ATTACHMENT 3, SAFETY EVALUATION FORM

Page 1 of 4		
ACTIVITY: Calvert Cliffs ISFSI USAR Change 50.59 Log No. _____ or 72.48 Log No. 94-0-101-001		
Based on the attached discussion, does this activity: <u>Applicable to 10 CFR 50.59 and 10 CFR 72.48 Safety Evaluations</u>		
<input type="checkbox"/> YES <input checked="" type="checkbox"/> NO <input type="checkbox"/> YES <input checked="" type="checkbox"/> NO <input checked="" type="checkbox"/> YES <input type="checkbox"/> NO	Involve an Unreviewed Safety Question (USQ)? Involve a change to the Technical Specifications/License Conditions or Bases? Require a change or addition to the UFSAR or USAR?	
<u>Applicable to 10 CFR 72.48 Safety Evaluations</u>		
<input type="checkbox"/> YES <input checked="" type="checkbox"/> NO <input type="checkbox"/> YES <input checked="" type="checkbox"/> NO	Involve a Significant Increase in Occupational Dose? Involve a Significant Unreviewed Environmental Impact?

ACTIVITY: Calvert Cliffs ISFSI USAR Change 50.59 Log No. _____ or 72.48 Log No. 94-0-101-001

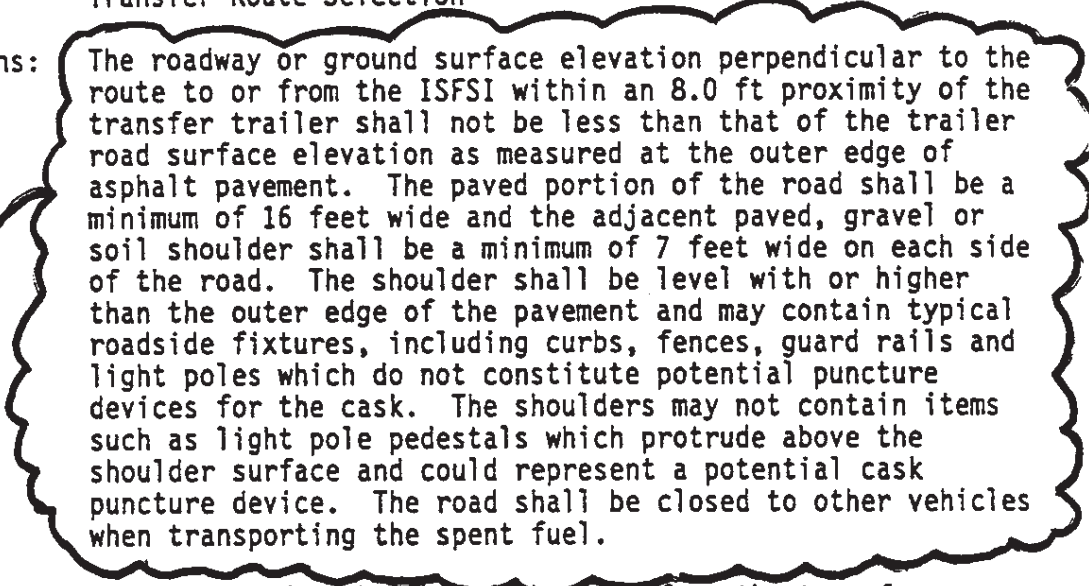
As stated in Section 2.1.1.1 of the CCNPP ISFSI ER, the minimum elevation difference between the ISFSI site and the plant site is 70 feet. Although statements are made in Sections 4.1.1 and 10.3.4.1 regarding the acceptability of the transportation route for the TC, provide more details on this road with specifics on the grading around the road and special provisions to ensure that the TC is not dropped greater than the 80 inches analyzed in the SAR during its transport over a 70 feet elevation gradient to the ISFSI site. What provisions will be made during the transport of the DSC to preclude the TC from rolling backwards on the slopped portion of the route in the event that the engine and brakes of the prime moving vehicle fail?

The transfer cask will be transported along an asphalt or concrete paved road which is 16 feet wide and has 7 to 8 feet shoulders. The road is approximately 3,300 linear feet with slopes which range from 0% to 3% except for an approximate 50 feet length which carries a 5.7% slope. The roadbed is level except for a negligible 1% slope required to create a crown in the road for drainage and a transverse slope at any point along the transportation route of less than 10%. The shoulders are either level with the road or slope up from the road. In those locations where the paved road abuts up to existing blacktop, or concrete paving, the shoulder is discontinued. The shoulder may be paved, gravel or soil and contain typical roadside fixtures, including curbs, fences, guard rails and light poles which do not constitute potential puncture devices for the cask during a drop. The shoulders do not contain items such as light pole pedestals which protrude above the shoulder surface and could represent a potential cask puncture device during a cask drop. For the entire route that the transfer cask is transported there will exist a minimum 8 feet wide zone that is at or above the roadbed elevation.

RESPONSE: (Revised by a 10 CFR 72.48 Safety Evaluation Process;
Pacific Nuclear File Nos. BG001.0051.01 and
BG001.0051.03.)

The transfer trailer braking system is not operable independent of the prime mover. However, failure of the prime mover will cause the trailer braking system to fail-safe, that is "lock tight".
